Access Compliance Report

Public Rights-of-Way

(Curb Ramps)

Intersection ID: 43669	Main Street: CORSICA_FOREST_DR	Cross Street: ASHETON_CREEK_DR	Location: E
ADA ID: 31060C819E67	Ramp Type: PerpDiag	Initial Pass/Fail: Fail	Overall Compliance: No
		Severity Score: 22.5

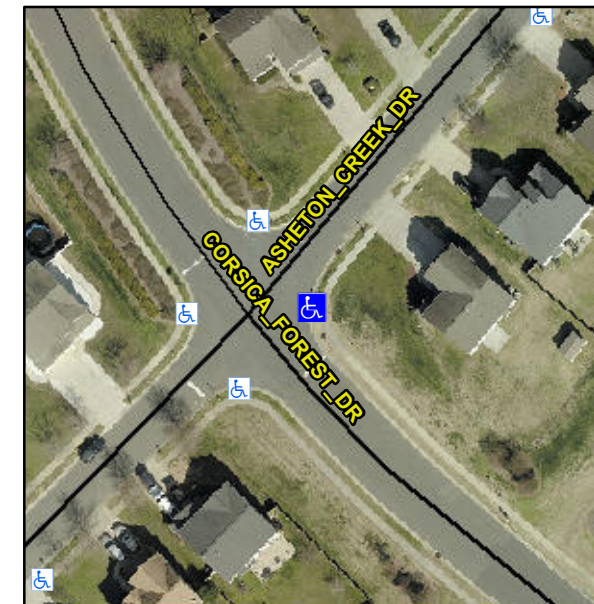
R304.5.1, R304.2.2, R304.5.3

Compliance	Description	Data	Compliance	Description	Data
N/A	Ramp Length (in)	52.0	No	Ramp Slope (%)	8.9
No	Ramp Width (in)	38.5	No	Ramp XSlope (%)	4.9
N/A	Flare Type LT	N/A	N/A	Flare Type RT	N/A
N/A	Flare Slope LT (%)	N/A	N/A	Flare Slope RT (%)	N/A
N/A	Flare Traversable LT?	N/A	N/A	Flare Traversable RT?	N/A
N/A	Landing Length (in)	N/A	N/A	DWS Provided?	N/A
N/A	Landing Width (in)	N/A	N/A	DWS Contrast?	N/A
N/A	Landing Slope (%)	N/A	N/A	DWS Length (in)	N/A
N/A	Landing X Slope (%)	N/A	N/A	DWS Full Width?	N/A
N/A	Landing Curb? (Y/N)	N/A	N/A	DWS Offset (in)	N/A
N/A	Shared Landing?	N/A			
N/A	Gutter Ponding?	N/A	N/A	Gutter Slope (%)	N/A
N/A	Gutter Lip Ht (in)	N/A	N/A	Gutter X Slope (%)	N/A
N/A	Painted X Walk1?	No	N/A	Painted X Walk2?	No
	X Walk 1 Direction	To NW		X Walk 2 Direction	To SW
N/A	X Walk 1 Width (in)	N/A	N/A	X Walk 2 Width (in)	N/A
	X Walk 1 Slope (%)	0.2		X Walk 2 Slope (%)	0.9
	X Walk 1 X Slope (%)	1.6		X Walk 2 X Slope (%)	1.9

Remove & Replace Curb Ramp With Two New Directional Ramps or Equivalent.
